# UNITED STATES PATENT AND TRADEMARK OFFICE

APPLICATION NO.	FILING DATE	FIRST NAMED INVENTOR	ATTORNEY DOCKET NO.	CONFIRMATION NO.
10/561,532	12/19/2005	Ronald Dekker	NL02 1153 US	9985
24738 7590 04/27/2010 PHILIPS INTELLECTUAL PROPERTY & STANDARDS PO BOX 3001 BRIARCLIFF MANOR, NY 10510-8001				
EXAMINER SHINGLETON, MICHAEL B				
ART UNIT		PAPER NUMBER		
2815				
MAIL DATE		DELIVERY MODE		
04/27/2010		PAPER

### Office Action Summary

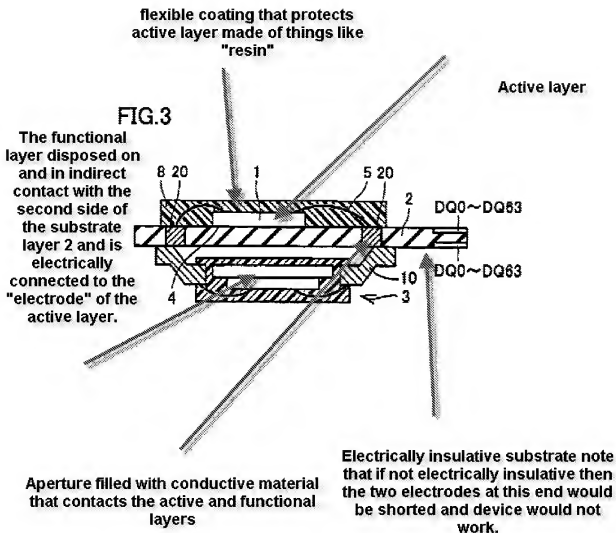
Claims 1 and 9 are rejected under 35 U.S.C. 102(e) as being clearly anticipated by Matsumoto US 6,798,679 (Matsumoto).

Claim 1 is so so extremely broad. First of all applicant still has not provided a proper drawing to an invention where the functional layer is on the “second side of the substrate”. What applicant now points to as element 15 is composed of the same exact material as that of 14 with is pure conductor as presented by the original disclosure. This just cannot be the functional layer, period. Again what was shown in the original disclosure was that of pure conductor and thus there continues to be clear new matter that must be cancelled in response to this office action. However, as stated above claim 1 is so so so extremely broad.

In essence claim 1 has a circuit on one side and a circuit on the other side of a substrate with a through hole connecting the two circuits. The only other thing added besides just stated is that there is a "flexible coating" formed on the "first side" of the substrate acting as a protective cover. Applicant should be well aware of the numerous flexible circuit boards that exist with through holes where the active or functional elements(layers) are mounted on both sides of the flexible circuit board and connected to each other via the through holes. More "rigid" versions like motherboards common in computers also are commonly known to exist with active and functional layers but all versions are flexible to some degree and applicant just has not claimed nor is there any support in the original disclosure to the degree, i.e. just how flexible is flexible as meant by applicant. The examiner wants to help applicant as much as possible to get to allowable subject matter and because there is no support for the degree of flexibility the examiner cannot suggest a limitation as to the degree as this would introduce new matter into the specification that has already been plagued with numerous errors. Matsumoto has been provided to show that the invention as set forth in claim 1, notwithstanding the new matter that exists in the present application, is anticipated by the prior art. The following reproduced drawing should make it clear that claim 1 is clearly anticipated but a few points are discussed as well to further emphasize this point. Applicant says that the active layer includes "at least one switching element". Well many things can be considered a "switching element" and as Matsumoto intends to use memory chips as the active layer the memory devices contained therein can be called "switching elements" as there state i.e. a 1 or a 0 is switchable. Resin is clearly flexible and is listed as one of the "flexible materials" by applicant. The term "monolithic" is likewise very broad. Clearly even applicant's invention is not "formed from a single crystal". Applicant's invention it is like that of Matsumoto "consisting of or constituting a single unit" i.e. monolithic. Should applicant like to have the examiner read a term like "monolithic" much more narrowly than is common practice then applicant should be aware of the recent case-law of Halliburton Energy Services, Inc v M-I LLC, Fed. Cir., 2007-1149 that states: "[b]ecause claims delineate the patentee's right to exclude, the patent statute requires that the scope of the claims be sufficiently definite to inform the public of the bounds of the protected invention, i.e., what subject matter is covered by the exclusive rights of the patent. Otherwise, competitors cannot avoid infringement, defeating the public notice function of the patent claims." As recited in the above Halliburton decision the court says "We note that the patent drafter is in the best position to resolve ambiguity in the patent claims, and it is highly desirable that the patent examiners demand that applicants do so in appropriate circumstances so that the patent can be amended during prosecution rather than attempting to resolve the ambiguity in litigation." Also note that the Halliburton decision relates to the situation where applicant is very
